UN Regulation No. 16 (Safety-belts)

Proposal for the 10 series of amendments to UN Regulation No. 16 (Safety-belts) *

Submitted by the expert from Finland

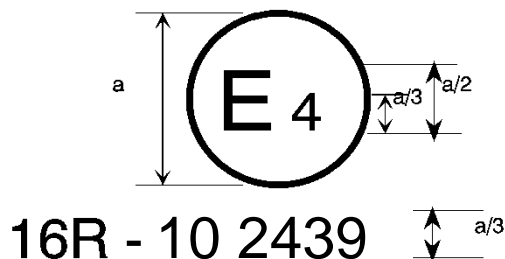
Paragraph 8.1.7. to 8.1.7.4., amend to read:

- "8.1.7. Every seating position in Annex 16 marked with the symbol ●, three-point belts of a type specified in Annex 16 shall be provided unless ~~one of the~~ following conditions is fulfilled, in which case two-point belts of a type specified in Annex 16 may be provided.
- ~~8.1.7.1. There is a seat or other vehicle parts conforming to paragraph 3.5. of Appendix 1 to UN Regulation No. 80 directly in front; or~~
- 8.1.7.2.1. No part of the vehicle is in or, when the vehicle is in motion, capable of being in the reference zone; ~~or.~~
- ~~8.1.7.3. Parts of the vehicle within the said reference zone comply with the energy absorbing requirements set out in Appendix 6 of UN Regulation No. 80.~~
- 8.1.7.4.2. Paragraphs 8.1.7.1. ~~to 8.1.7.3.~~ shall not apply to a driver's seat."

2. Arrangements of the safety-belt approval marks (see paragraph 5.3.5. of this Regulation)

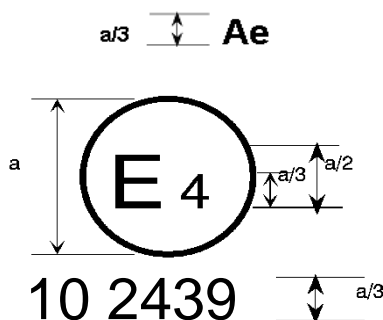
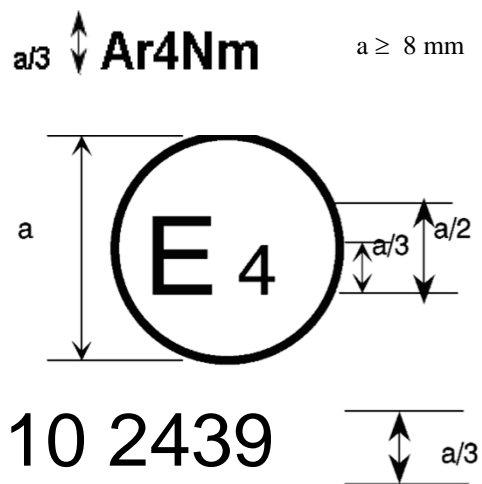
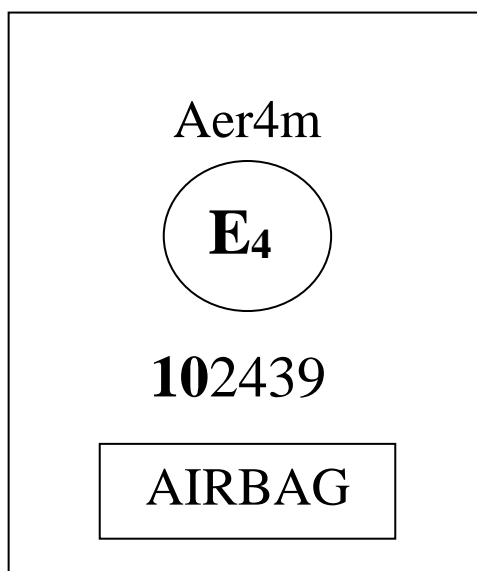
The belt ... the 06, 07, 08, ~~09~~ or **10** series of amendments at the time of approval.

The belt ... 06, 07, 08, ~~09~~ or **10** series of amendments at the time of approval.

The belt bearing ... the 06, 07, 08, ~~09~~ or **10** series of amendments at the time of approval.

The belt ... the 06, 07, 08, ~~09~~ or **10** series of amendments at the time of approval.

The belt ... the 06, 07, 08, ~~09~~ or 10 series of amendments at the time of approval. This belt shall not be fitted to vehicles of category M_1 .

The ... 06, 07, 08, ~~09~~ or 10 series of amendments at the time of the approval. This safety-belt has to be fitted to a vehicle equipped with an airbag in the given seating position"
